REGULATORY INFORMATION DISTRIBUTION SYSTEM (RIDS)

SUBJECT: Forwards marked-up Chapter 14 to FSAR, reflecting changes to accelerated test program per current commitments for review & approval. Justification & other changes startup test program also encl.

Re: Nine Mile Point Unit 2
Docket No. 50-410

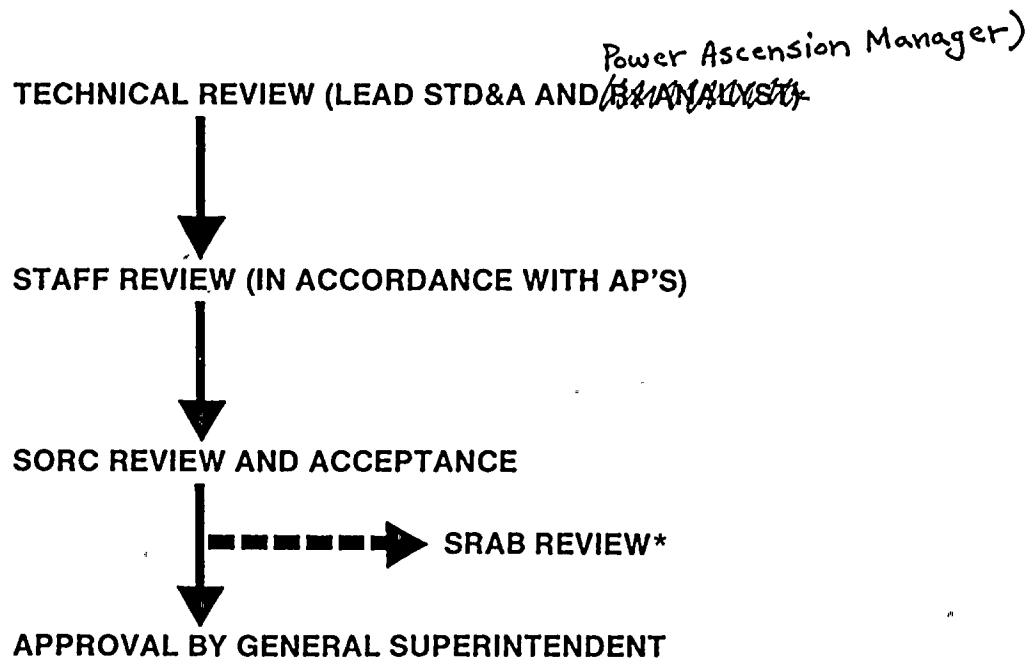
22

~~at maximum gain~~

FIGURE 14.2-233-1

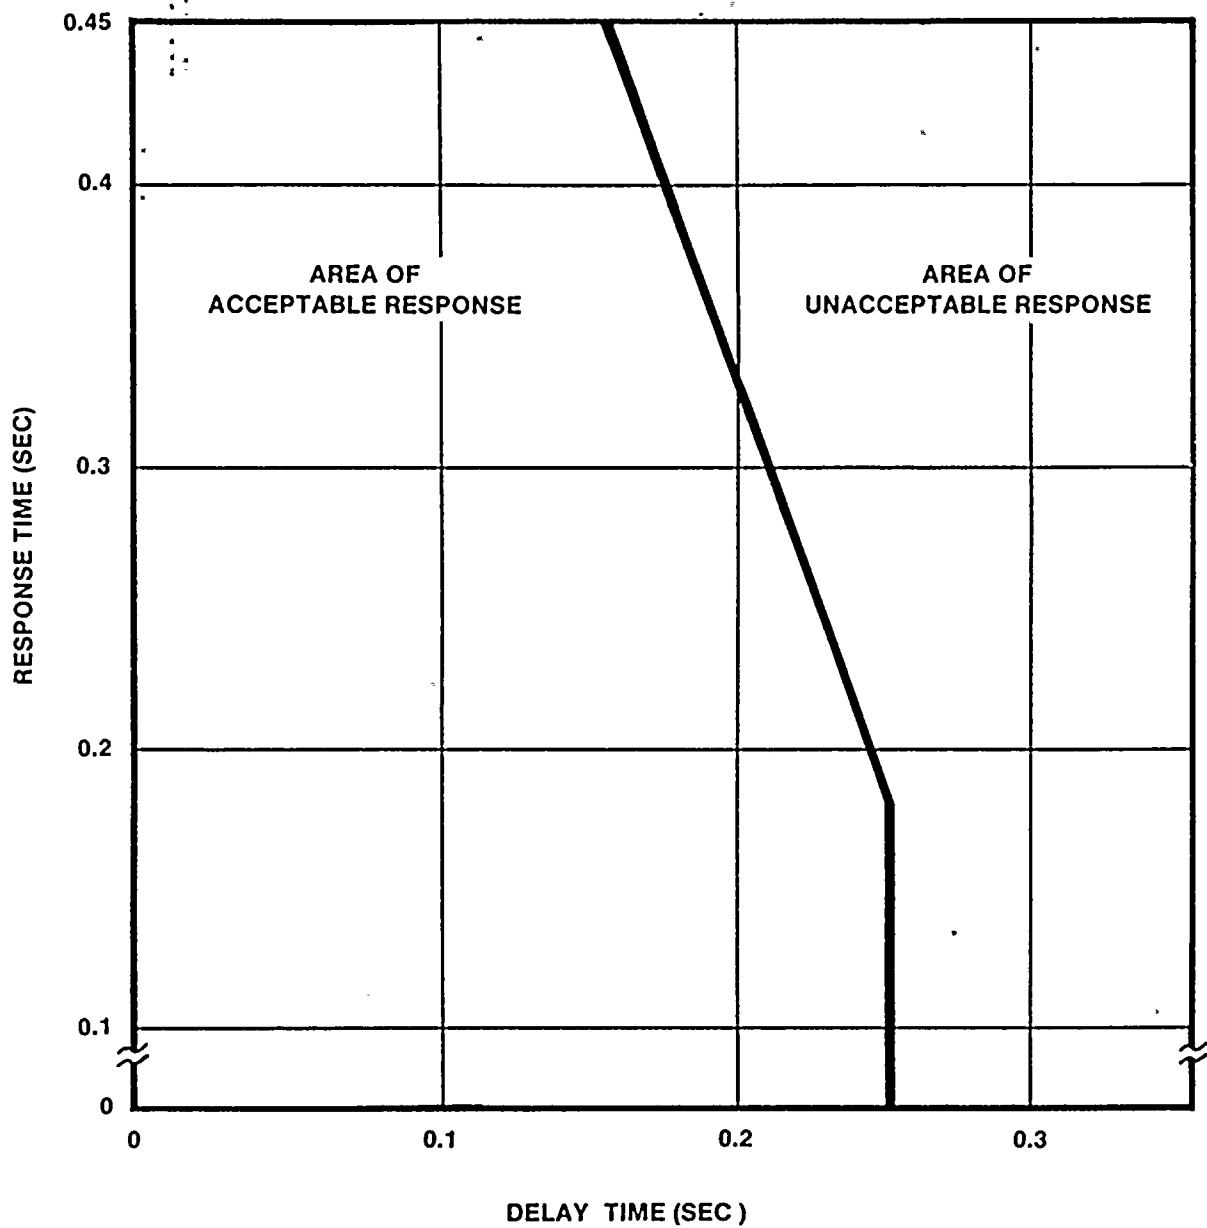
For step inputs of 0.2 percent to 0.5 percent (see Figure 14.2-233-1)

For step inputs of 0.5 percent to 5 percent ≤ 0.45 sec

For step inputs of 0.2 percent to 0.5 percent (see Figure 14.2-233-1)
